BEFORE THE COLORADO WATER CONSERVATION BOARD

AMENDED NOTICE TO CONTEST INSTREAM FLOW APPROPRIATIONS

RE: CWCB ISF Recommendations, Yellow Creek (Upper) and Yellow Creek (Lower)

Pursuant to your request, Resource Engineering, Inc. (RESOURCE) has completed a review of technical information developed by the Bureau of Land Management (BLM) and Colorado Water Conservation Board staff (CWCB) in preparation for application of instream flow water rights on Yellow Creek, tributary to the White River. The CWCB plans to apply for instream flow (ISF) water rights within two segments of Yellow Creek; both located in the lower region of the basin near its confluence with the White River. The reaches are identified as Yellow Creek (Upper) and Yellow Creek (Lower) and are shown graphically in **Figure 1**, attached.

**Figure 2: Yellow Creek (Upper)
ISF Claim**

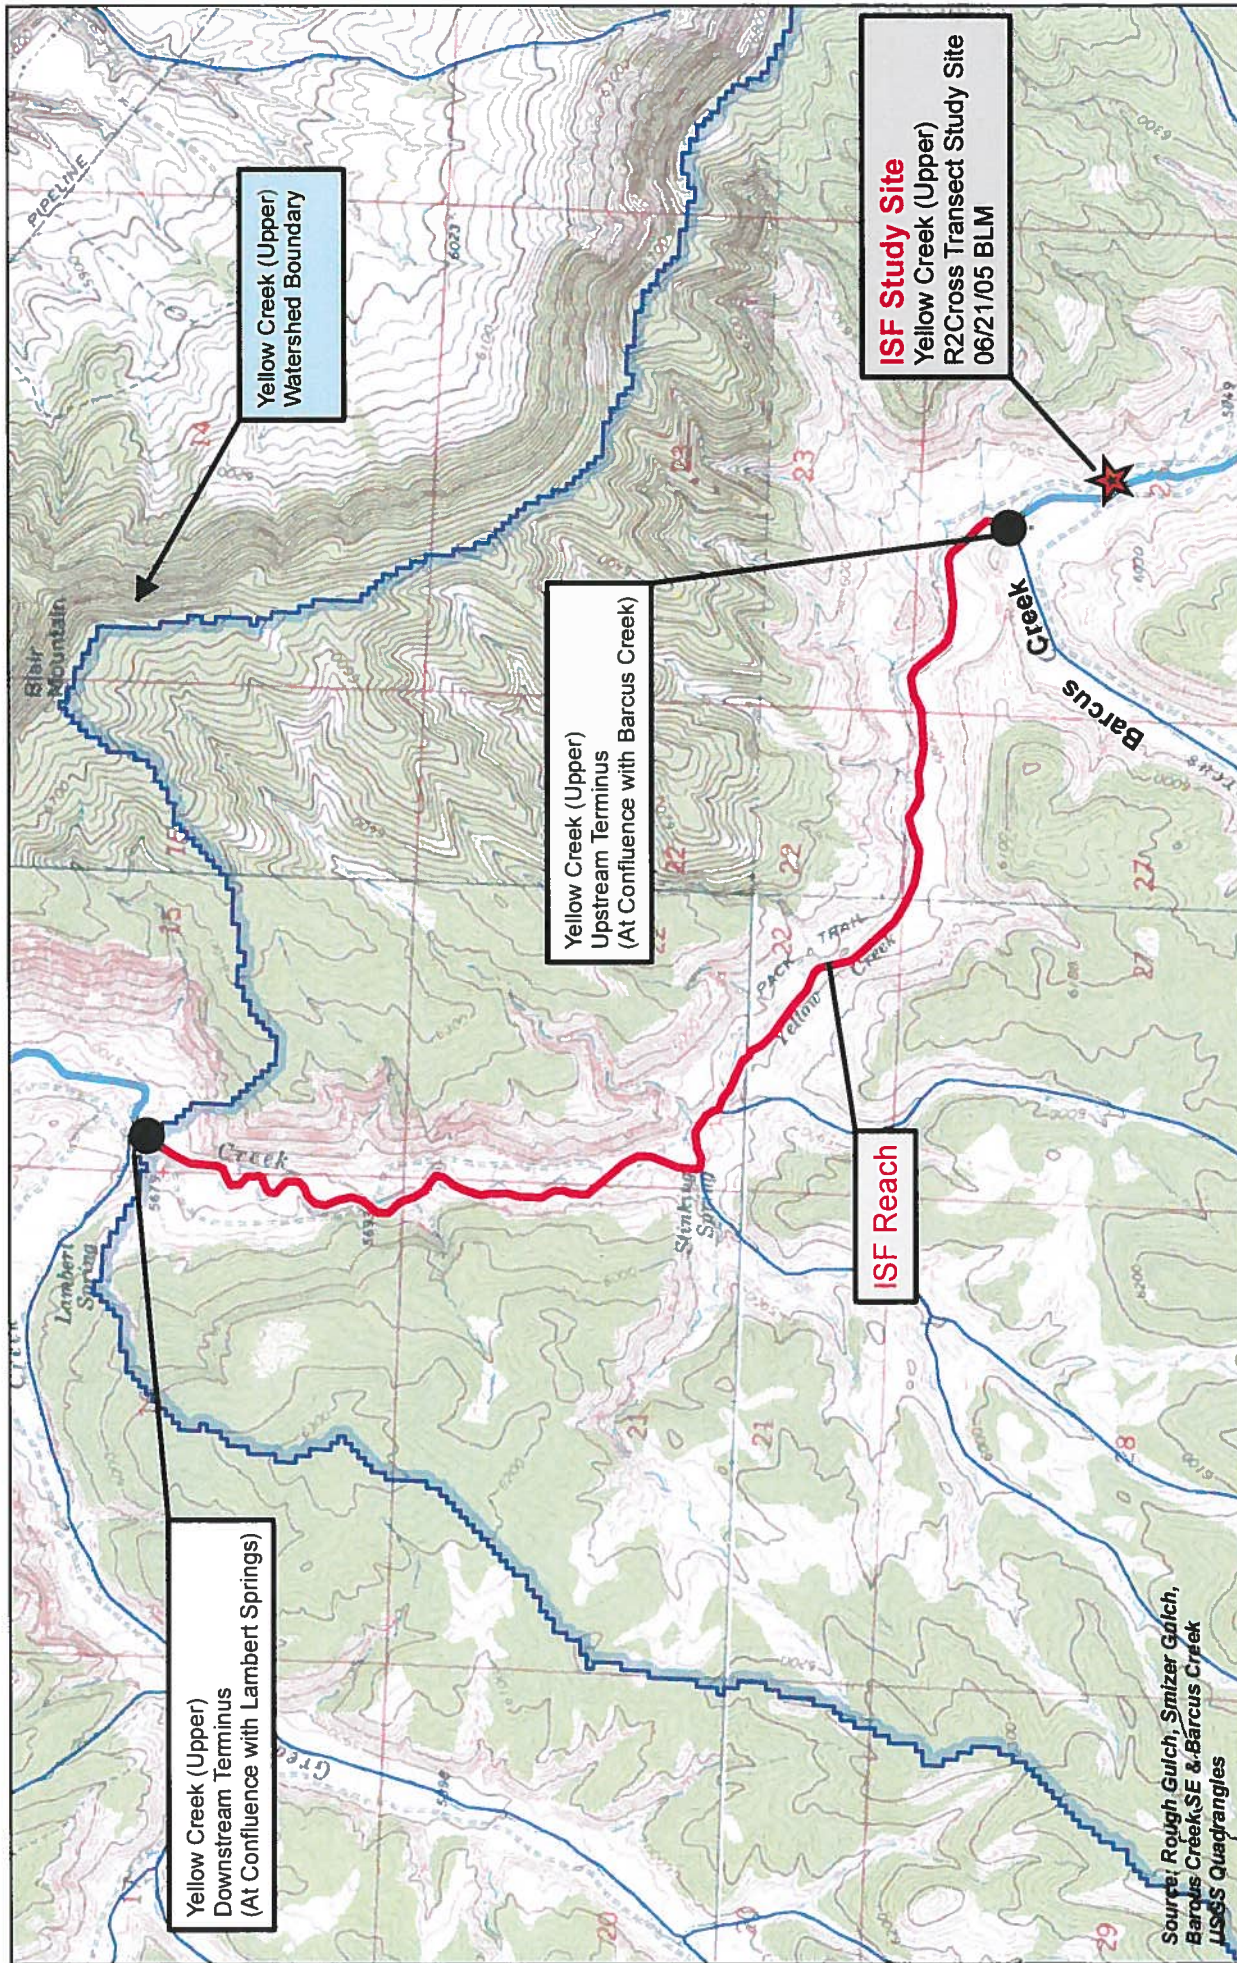
The problem with this recommendation, however, is that the only study transect used to quantify the summer ISF is not located within the defined Yellow Creek (Upper) ISF reach. Rather, it is located approximately 1/3 mile upstream of the confluence of Yellow Creek and Barcus Creek, the upper terminus of the claimed ISF reach. Although the submitted R2Cross data sheets label the location of the study transect as; "1,800 feet d/s from conf. w/Barcus Creek" (within the study reach), we believe this description to be in error. Review of the original field notes which include both a written description and an associated latitude and longitude that place the study site upstream of the Barcus Creek confluence. Accordingly, the data collected and relied upon by the agencies to quantify the summer ISF is not representative of the Yellow Creek (upper) ISF reach and therefore, should be disregarded. This leaves no viable data to support a summer ISF within this reach. The location of the BLM/CWCB study site in relationship to the upper ISF reach is shown in **Figure 2**.

Attachment 1

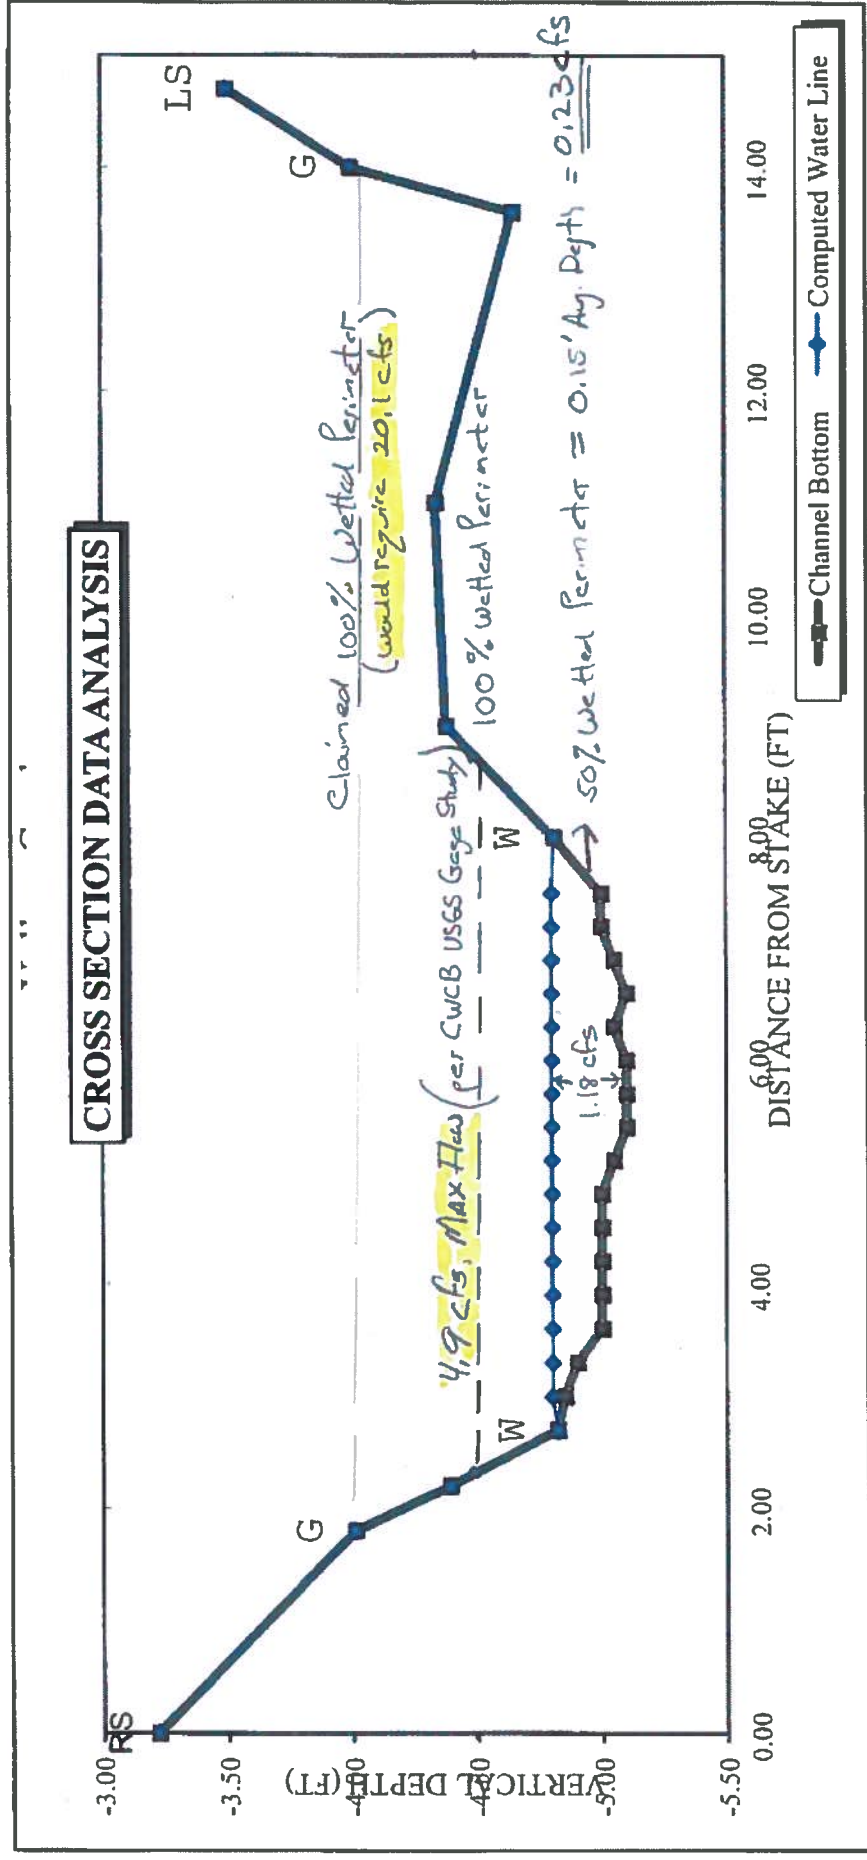
In evaluation of the BLM/CWCB supporting data, however, it is apparent that the investigators have erred in their application of the R2Cross methodology. In quantification of a summer ISF, one of the three hydraulic characteristics that must be met includes a streamflow capable of inundating 50% of the defined wetted perimeter. A 100% wetted perimeter would be that length of channel cross section as measured from the grassline of one streambank to the grassline of the opposite streambank and thus, is representative of bank full conditions that occur during seasonally high streamflows. The ISF streamflow selection criteria would be satisfied at a depth of water that would cover 50% of this defined high flow channel length (cross section length). In this study, it appears that the 100% bankfull width was not correctly identified in either study transect and therefore, the assumed flow that would occur at the 50% wetted perimeter is not correct. In one of two of the study transects, the error results in a significant overestimate of the streamflow necessary to satisfy the 50% criteria. As a result, the claimed ISF is not representative of the minimum amount of water necessary to preserve the natural environment to a reasonable degree.

Attachment 1 and **Attachment 2** show the channel cross sections of the two study sites as contained in the agencies referenced materials. Hand notes have been placed on the cross sections by RESOURCE to display the water elevation and corresponding streamflow that would occur at the 100% wetted perimeter that was identified by the BLM/CWCB. **Attachment 1** represents the study transect that was evaluated with a corresponding measured streamflow of 1.19 cfs. At the 100% wetted perimeter identified by the investigators, the streamflow of Yellow Creek would have to be at a flow of 20.1 cfs. The CWCB's water availability analysis contained in the executive summary, however, shows that maximum streamflow occurring at this site is approximately 4.9 cfs (**Attachment 3**). The daily streamflow summary was based upon review of a nearby USGS streamflow gage. The measured data indicates that the 100% wetted perimeter should have been placed at an elevation in the cross section closer to streamflow conditions at 5 cfs, not 20 cfs. The resulting error is significant. The BLM/CWCB staff conclude that the 50% wetted perimeter criteria would be met at a flow of 3.31 cfs when in fact, it appears that the criteria is met at flows of approximately 0.2 cfs. The reason that the criteria can be met at lower flows is attributed to the characteristics of the channel within the lower reach. Both transects have a high width/depth ratio. A similar mistake was made with respect to the second transect that was studied at a flow rate of 1.04 cfs. The defined 100% wetted perimeter would require streamflows of approximately 17 cfs (**Attachment 2**). If the 100% wetted perimeter was properly located at an elevation supporting a flow of approximately 5 cfs (bank full), the wetted perimeter criteria would be satisfied at a lower streamflow. Due to these apparent errors, the summer ISF recommendation the Yellow Creek (lower) reach appears to be significantly over stated.
